# RENESAS TECHNICAL UPDATE

Product Category	MPU/MCU		Document No.	TN-SY*-A0043A/E	Rev.	1.00
Title	Errata for User's Manual regarding the IIC		Information Category	Technical Notification		
Applicable Product	Renesas Synergy™ S5D3 MCU Group	Lot No.	Reference Document	S5D3 Microcontroller Group User's Manual Rev.1.10		
		All

The specified Renesas Synergy S5D3 User's Manual has incorrect statements about the IIC.

## Page 935 of 1579

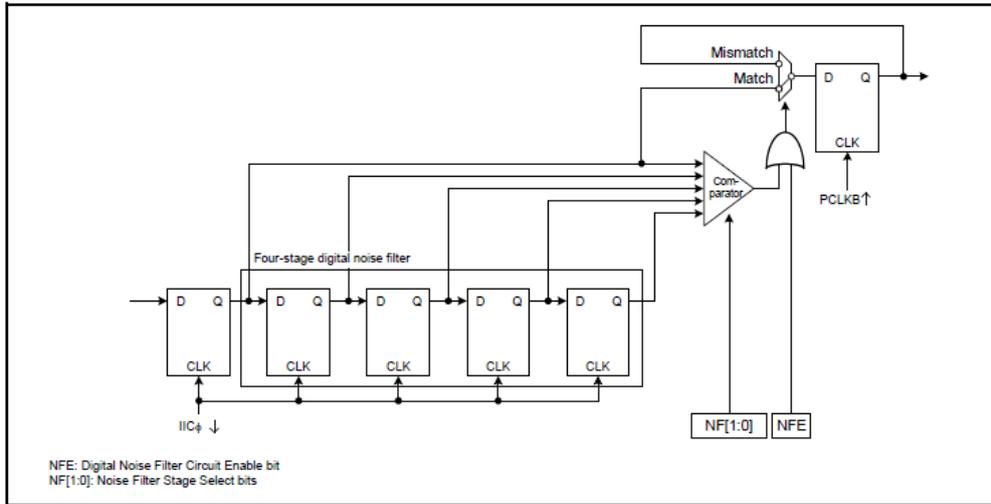
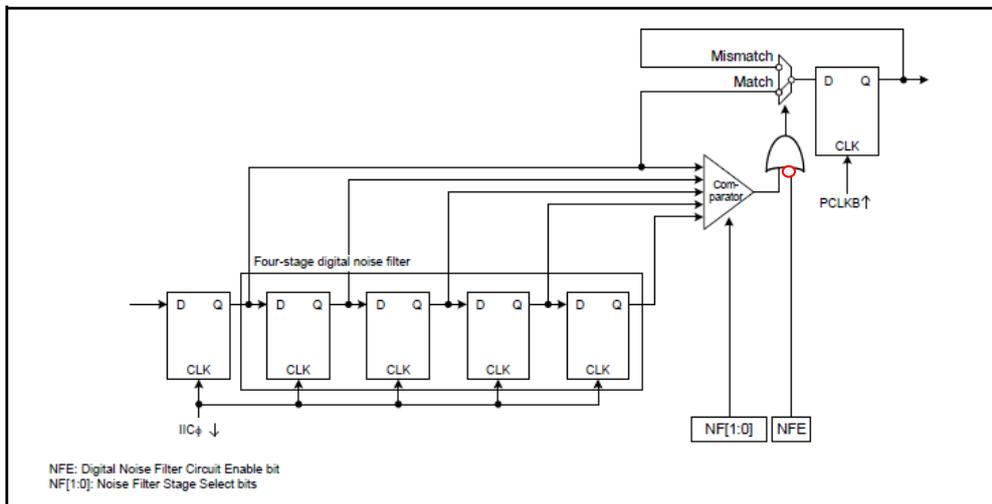
Incorrect Figure

Correct Figure

Incorrect Figure

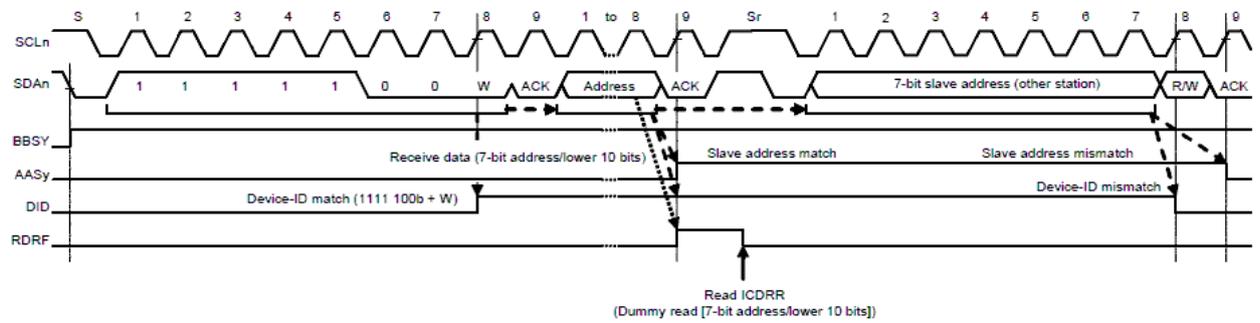
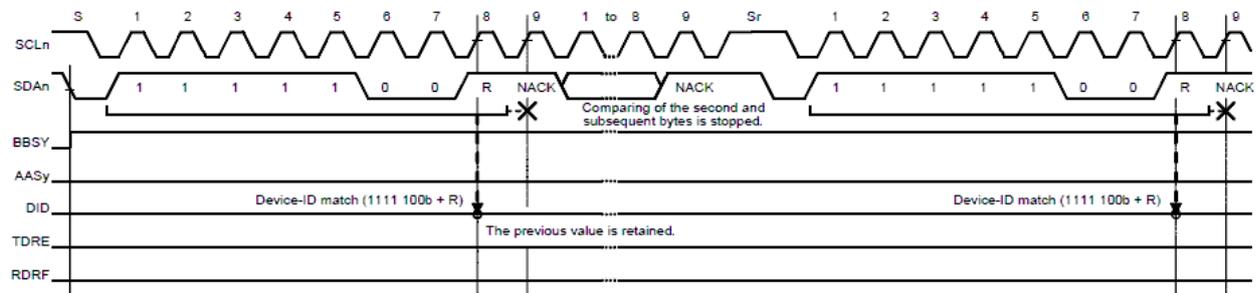
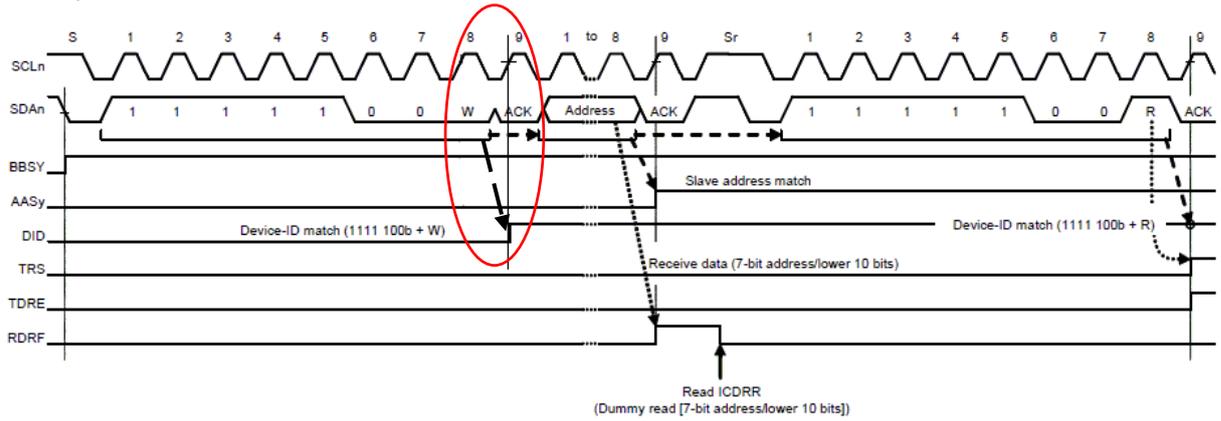
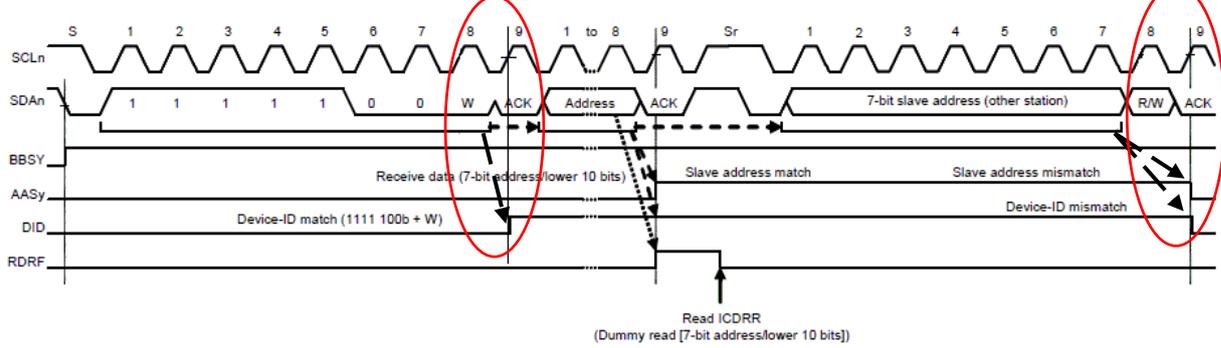
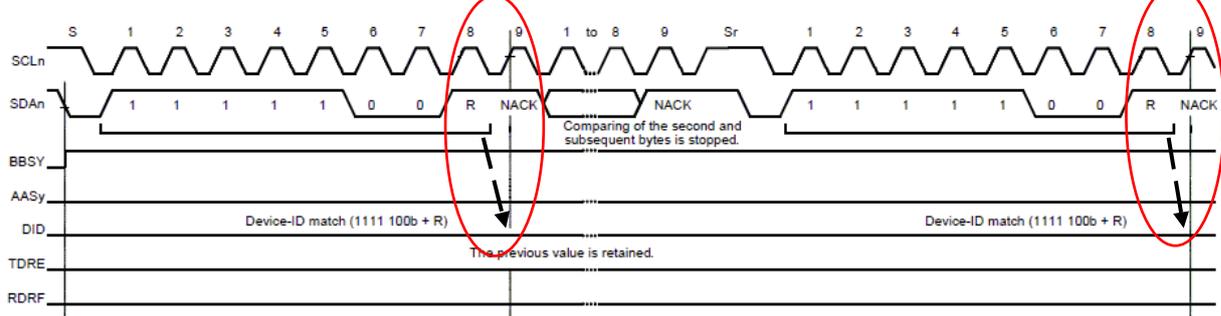
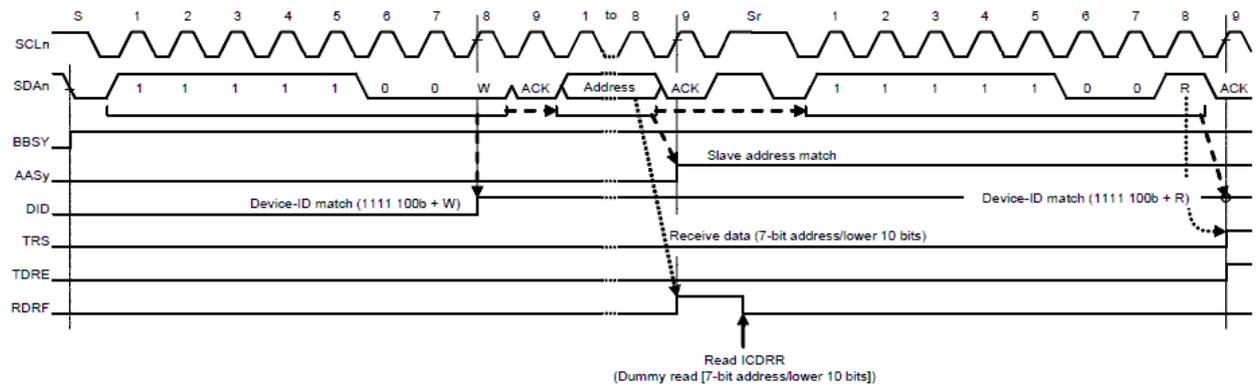
Device-ID reception

When address received after a restart condition is detected does not match the device-ID

When address before the device-ID + R does not match the slave address

Device-ID reception

When address received after a restart condition is detected does not match the device-ID

When address before the device-ID + R does not match the slave address

Page 975 of 1734

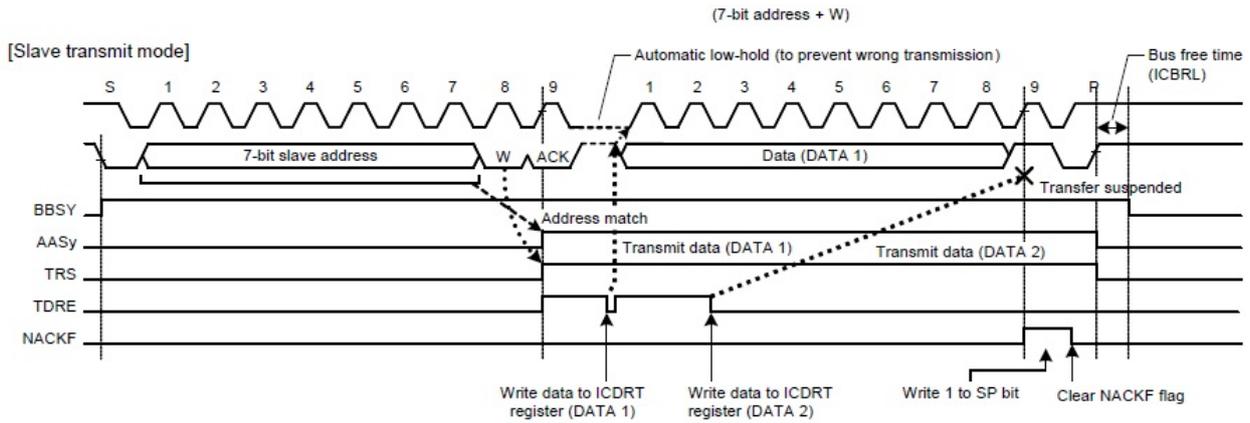
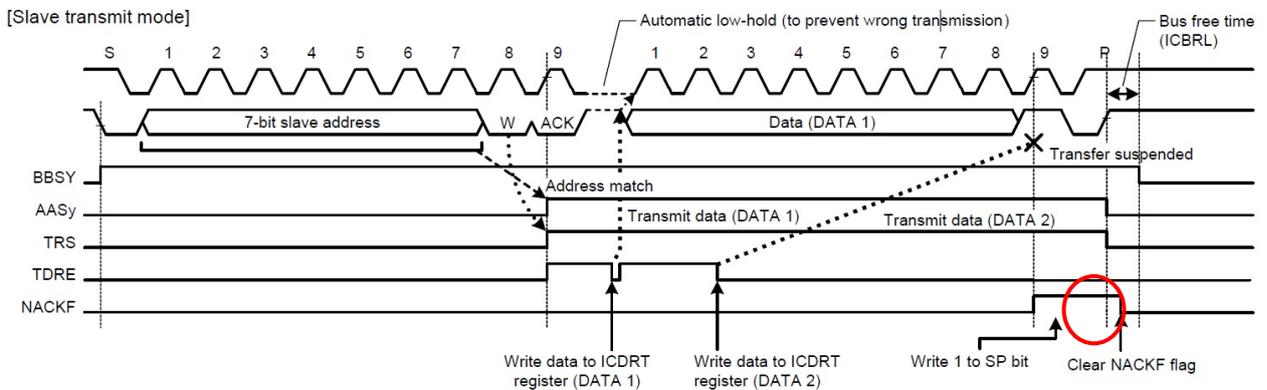
Incorrect Figure

Correct Figure

Page 984 of 1579

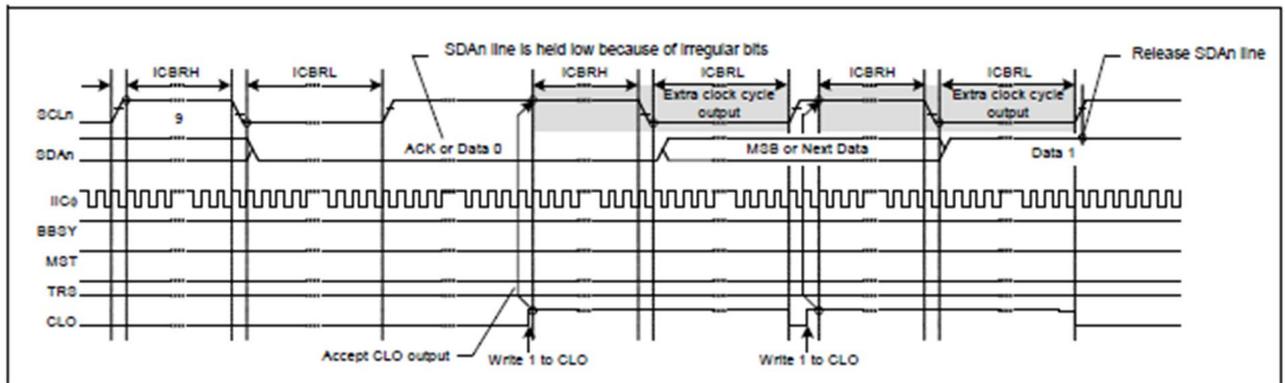
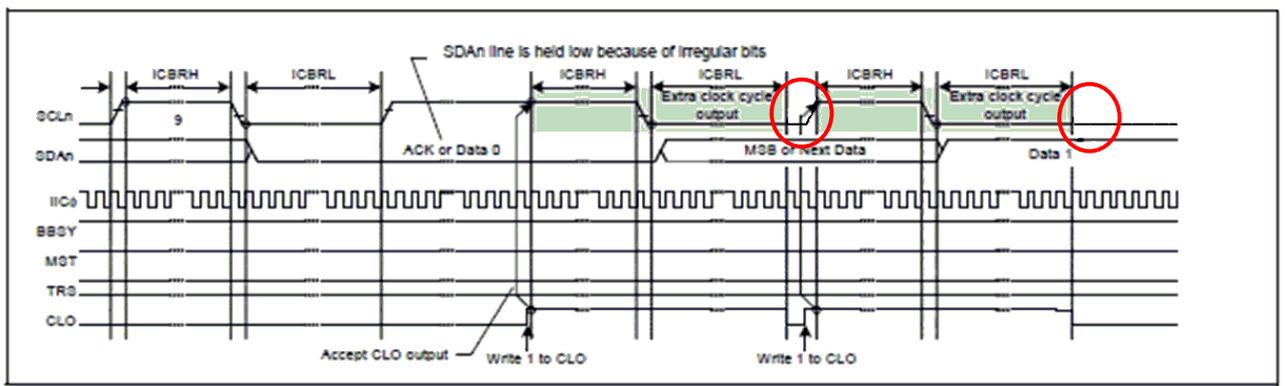
Incorrect Figure

Correct Figure
